Technical *data*

CT 939 K2/K3 & CT1120K1 timing belt kit, used for example in:
VW / Audi 2.5 TDI 5 cyl.

Fig. 2
Installed position

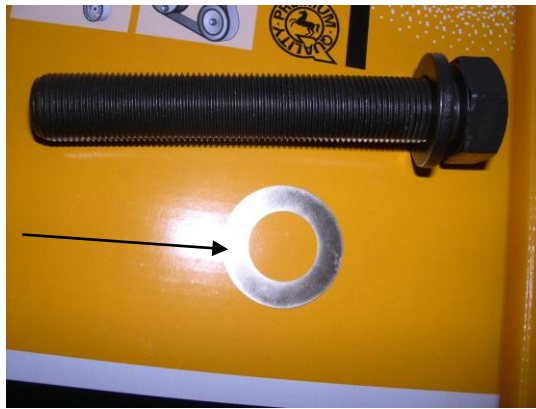
In accordance with the updated equipment status, the timing belt kit contains a thin washer (diamond-coated) that was not previously installed in the vehicle.

According to the VW/Audi catalog, this special washer (4) is to be installed between the crankshaft drive wheel (3) and the torsional vibration damper (5). This is intended to improve the co-efficient of friction.
